ADDENDUM No. 1

Project	T.A. Blakelock H.S. Renovations - Phase 1	Project No.	2215A
Location	1160 Rebecca Street, Oakville, Ontario	Date of Issue	2023 03 27
Owner	Halton District School Board	File	2215/7.1.3

This Addendum forms part of the Contract Documents and amends the original Drawings and Specifications, dated 2023 03 16, as noted below.

Job No. 2215A Drawing No. A801

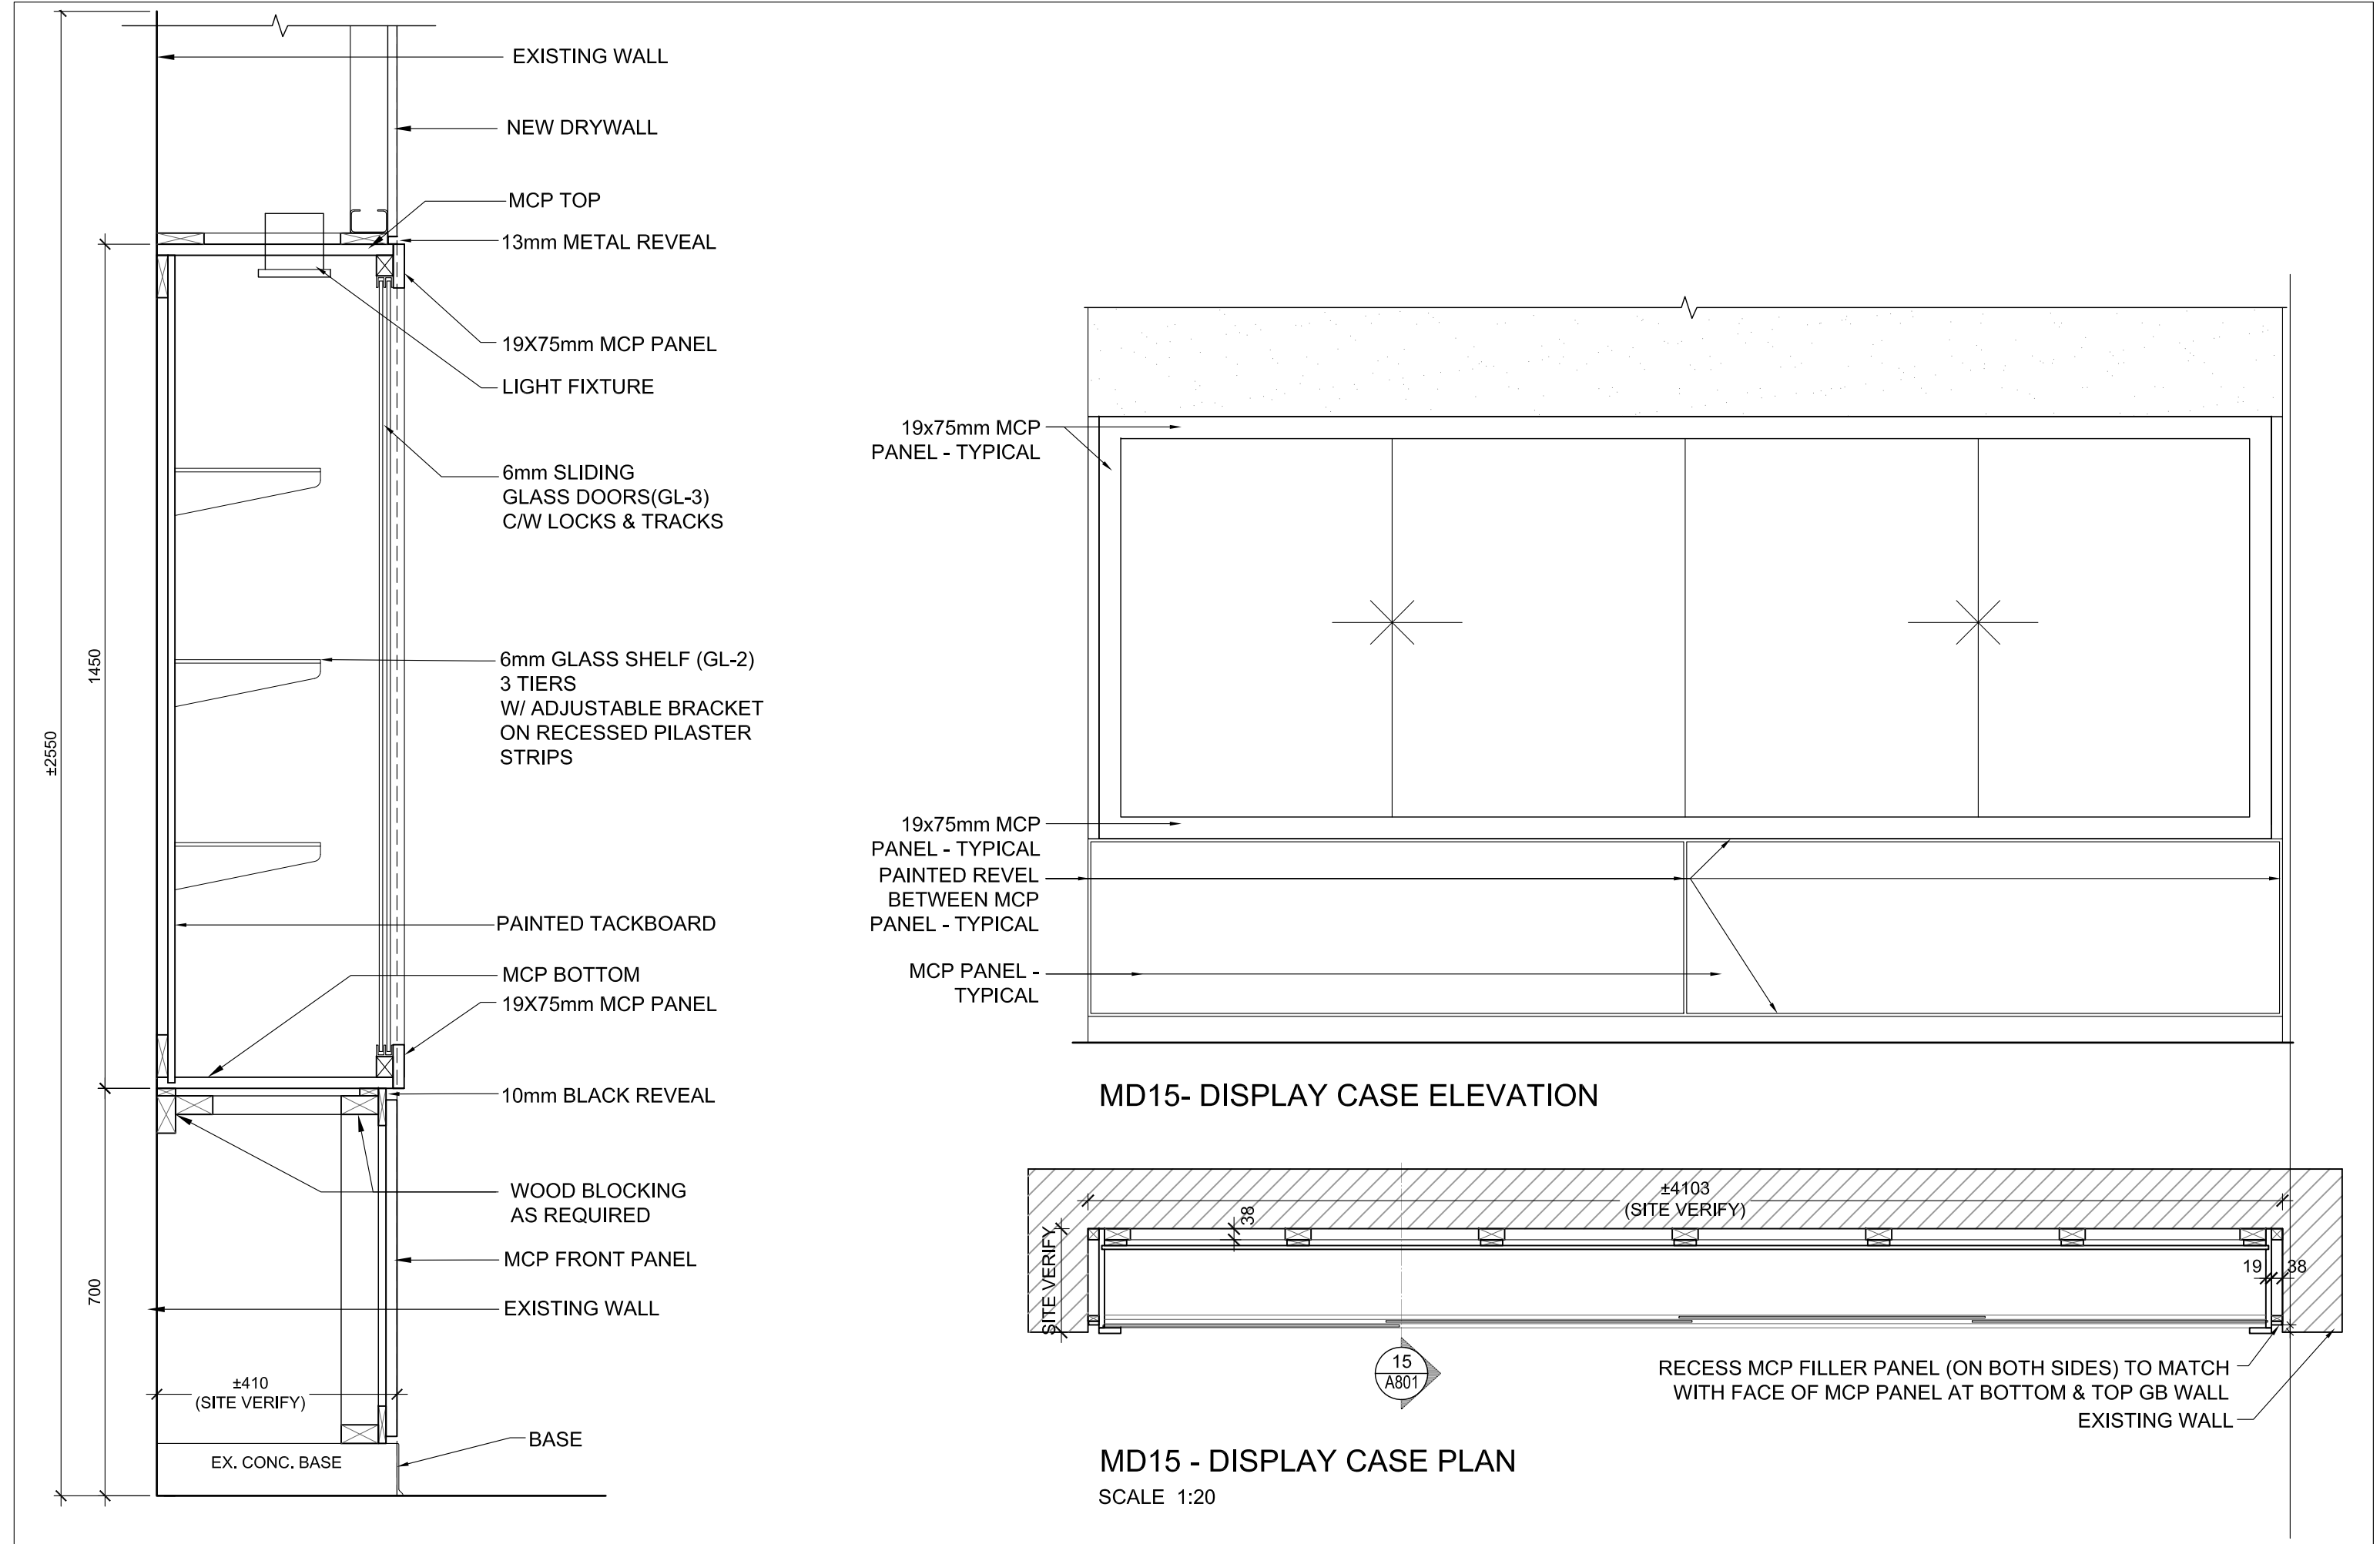
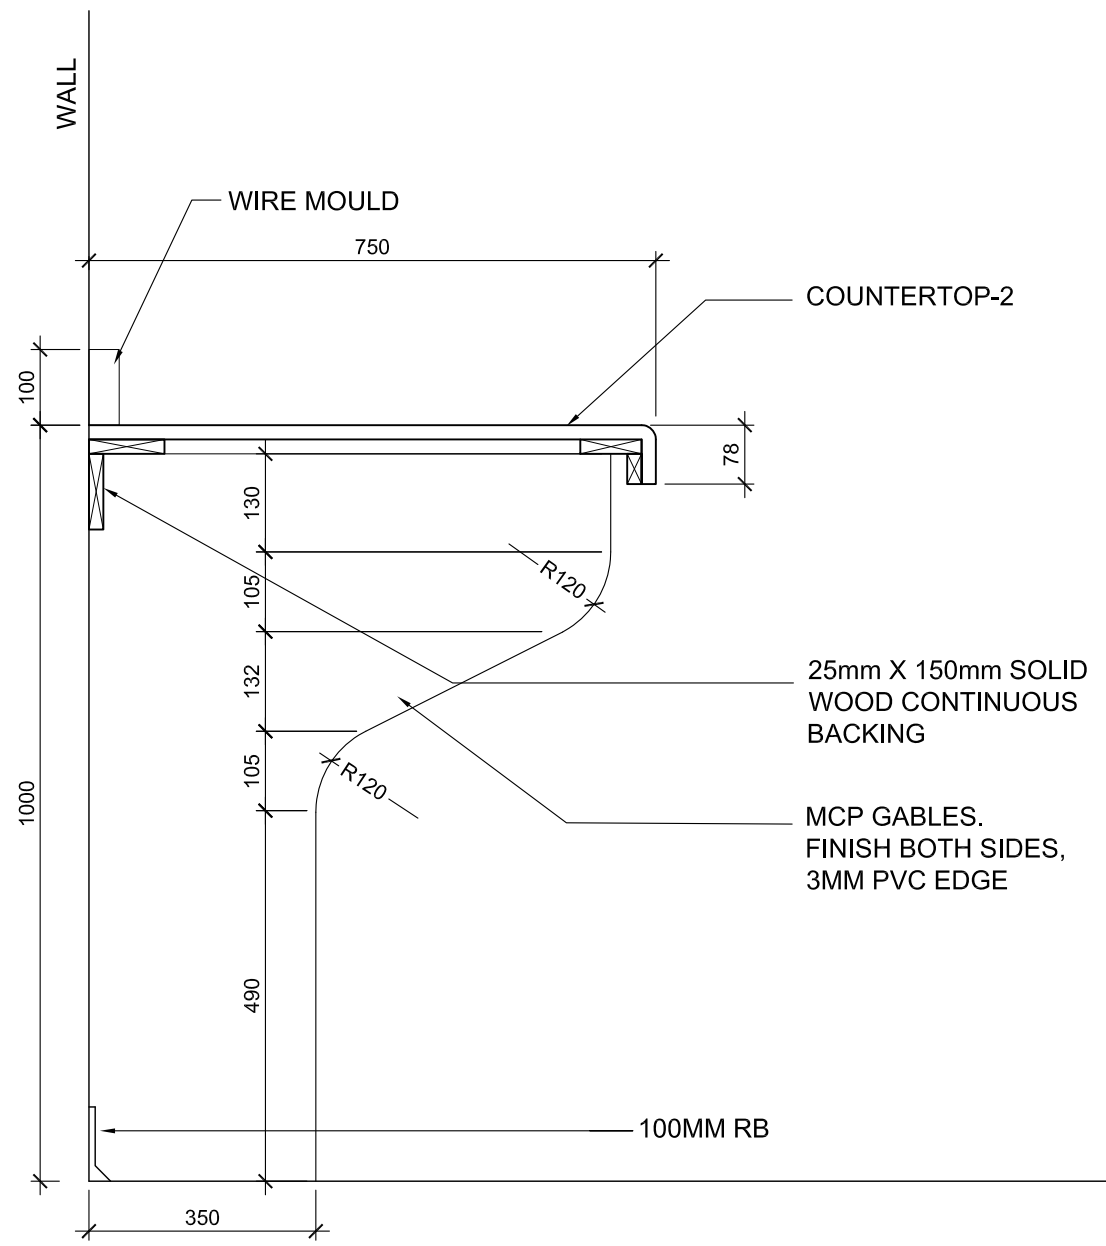
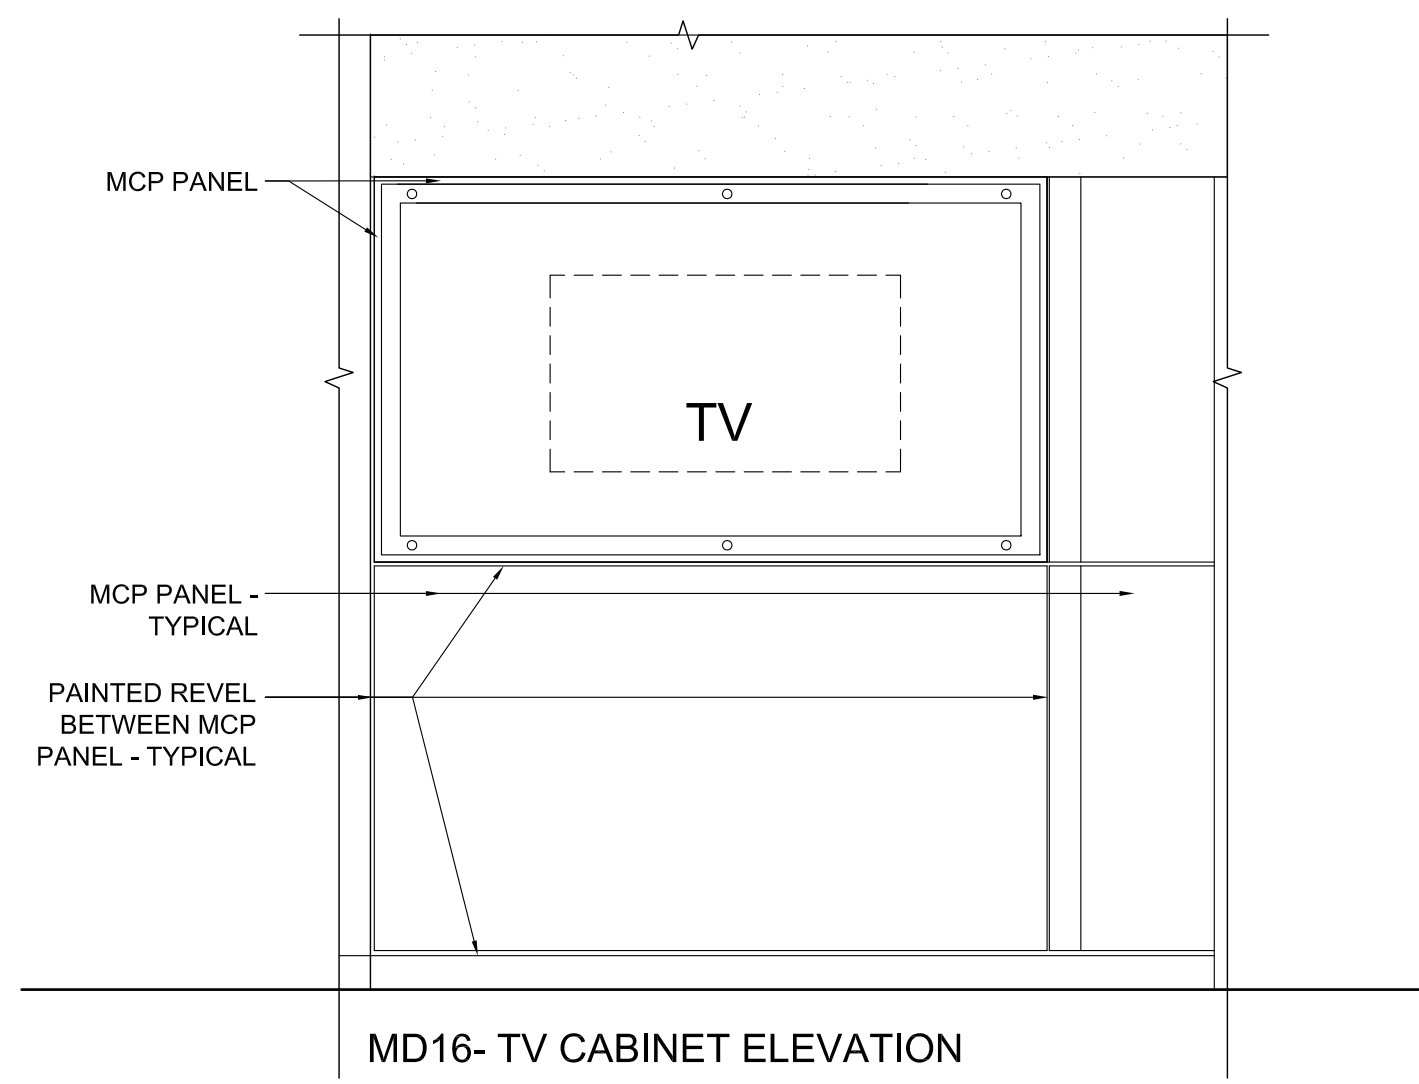
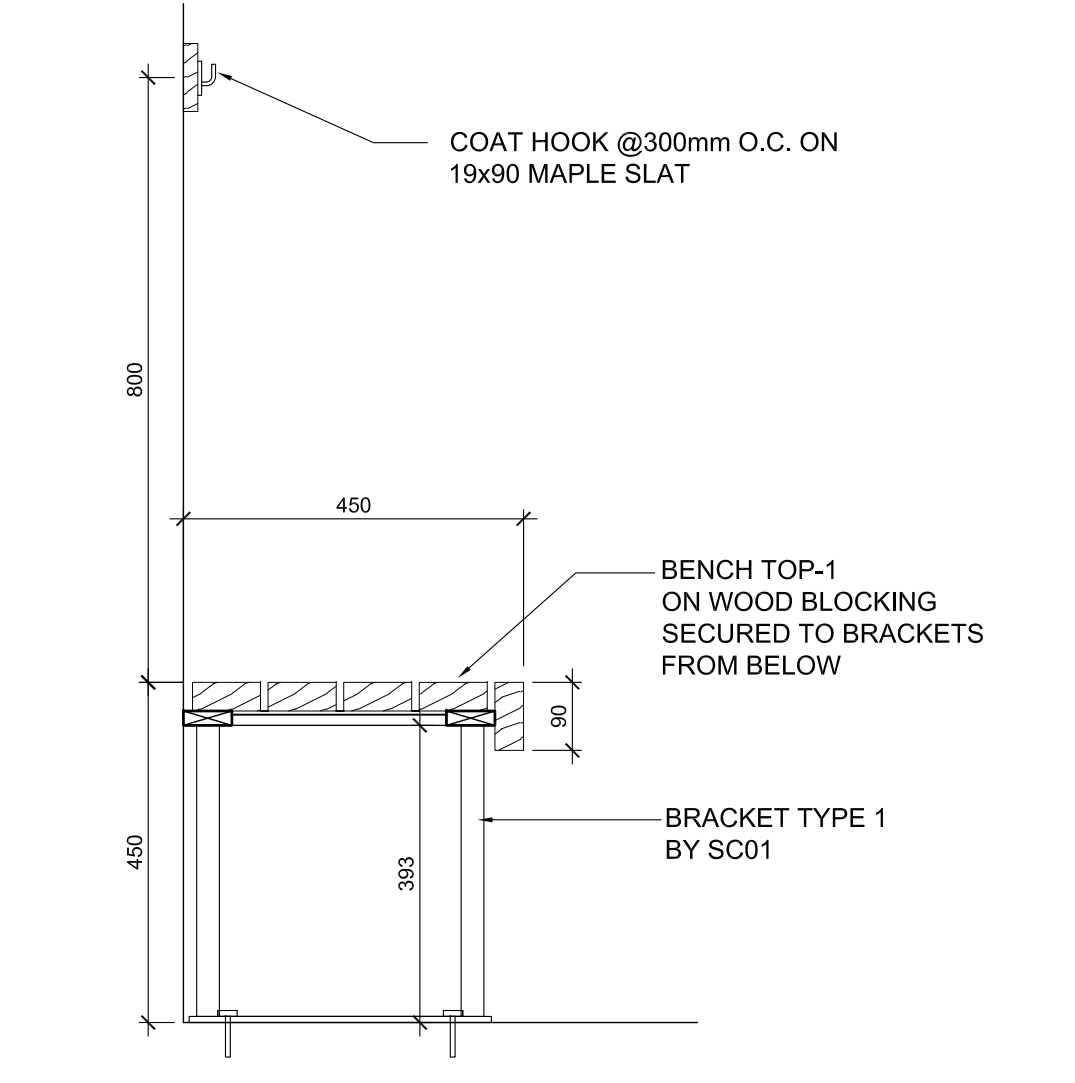
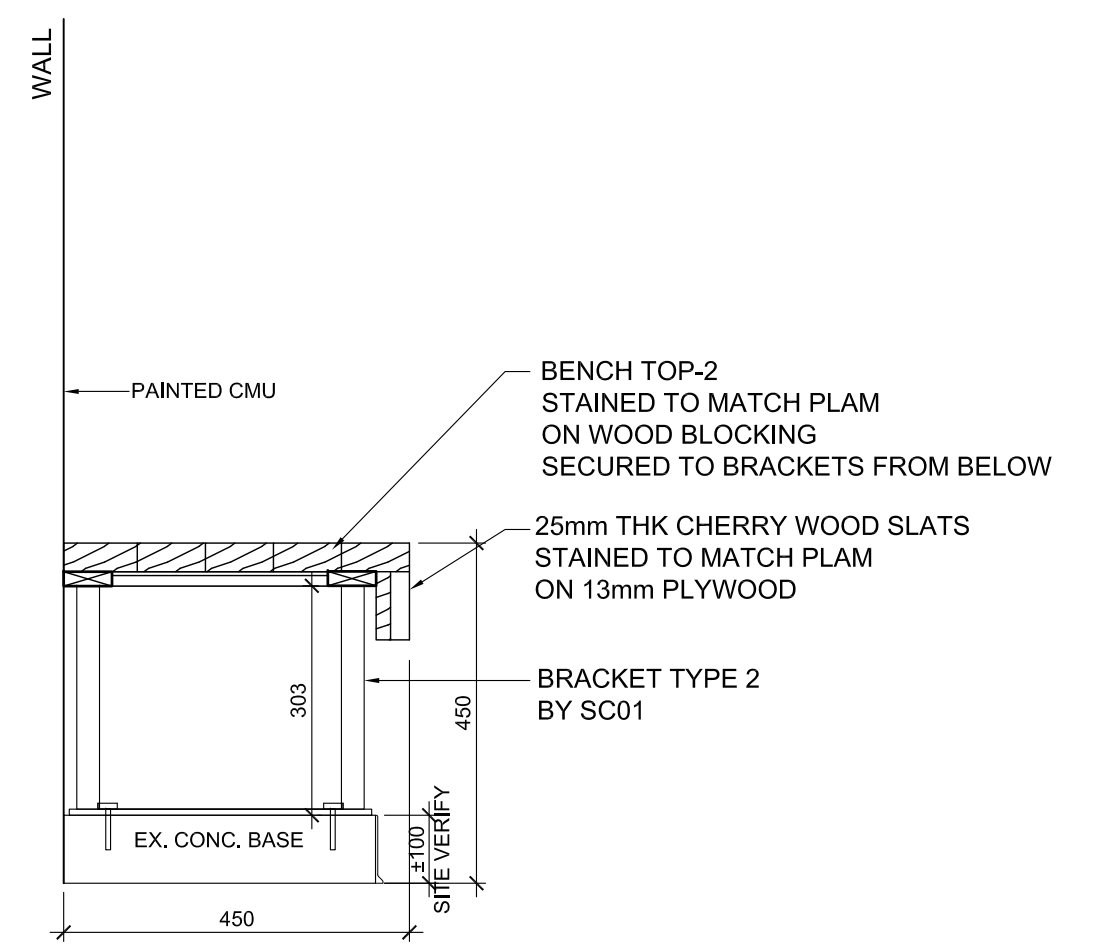
.1 Revise “*Typical Millwork Construction*” notes, and “*Millwork Notes*” to match text as per attached Drawing A801 Millwork Details, Revision No. 1

TYPICAL MILLWORK CONSTRUCTION

- MILLWORK NOTES:**
- PROVIDE CONTINUOUS BLOCKING BEHIND MILLWORK AS NECESSARY; SEAL ALL MILLWORK @ WALL / FLOOR INTERSECTIONS. UNITS TO BE PROVIDED WITH FILLER PANELS, SIZES AS REQUIRED, TO ENCLOSE ENDS AT ADJACENT UNITS OR WALLS.
 - SLIDE BOLTS: PROVIDE TOP AND BOTTOM SLIDE BOLT ON THE LEFT DOOR FOR ALL TALL CUPBOARDS.
 - ALL MILLWORK DOORS AND DRAWERS TO BE LOCKABLE.
 - ALL FASTENERS TO BE NON-CORROSIVE TYPE.
